MINERALS PROGRAM INSPECTION REPORT
PHONE: (303) 866-3567

MINE NAME: Cresson Project	MINE/PROSPECTING ID#: M-1980-244	MINERAL: Gold	COUNTY: Teller
INSPECTION TYPE: Monitoring	INSPECTOR(S): Patrick Lennberg	INSP. DATE: October 28, 2021	INSP. TIME: 08:00
OPERATOR: Cripple Creek & Victor Gold Mining Co.	OPERATOR REPRESENTATIVE: Jeana Ratcliff	TYPE OF OPERATION: 112d-3 - Designated Mining Operation	
REASON FOR INSPECTION: Normal I&E Program	BOND CALCULATION TYPE: None	BOND AMOUNT: \$209,491,188.00	
DATE OF COMPLAINT: NA	POST INSP. CONTACTS: None	JOINT INSP. AGENCY: None	
WEATHER: Clear	INSPECTOR'S SIGNATURE: 	SIGNATURE DATE: November 29, 2021

Photo 11: Reclaimed drill pad area with stormwater controls in place downgradient of pad and sediment has been removed from wildlife fence

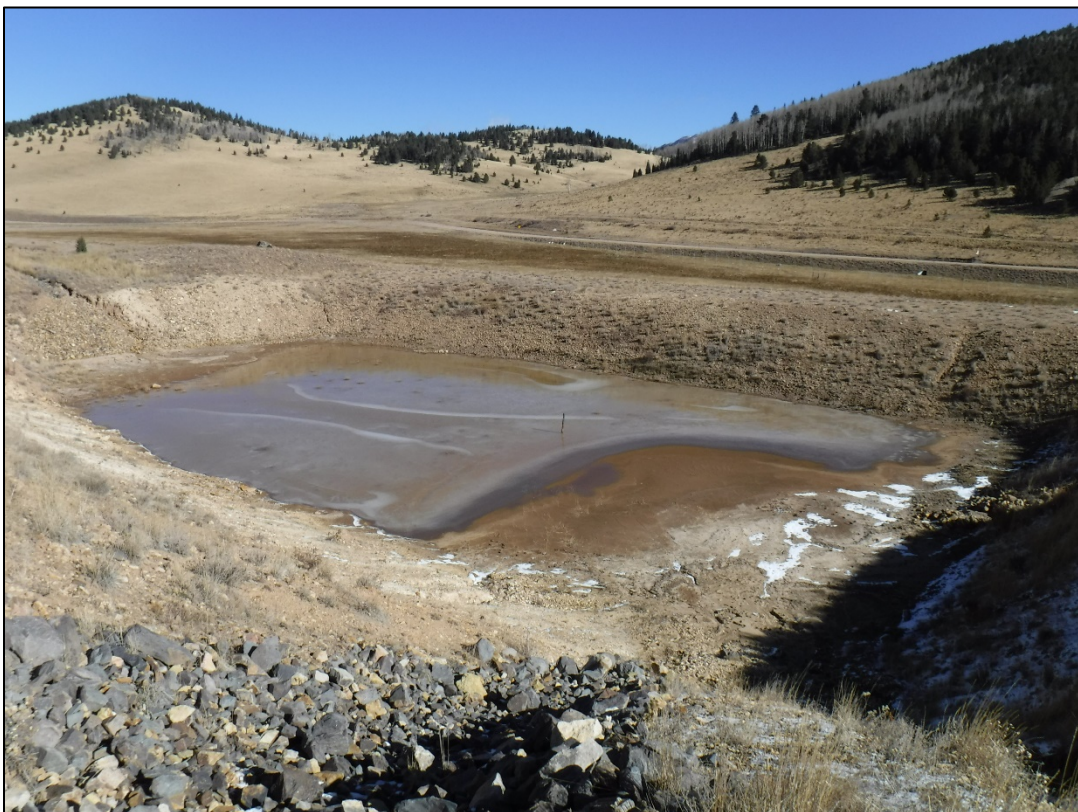
Also noted was the drill pad was in the process of being reclaimed and were waiting to broadcast seed the area. Straw wattles had been placed downgradient of the disturbed area for erosion control. The material that was up against the wildlife fence, observed in August 10th inspection, had been removed.
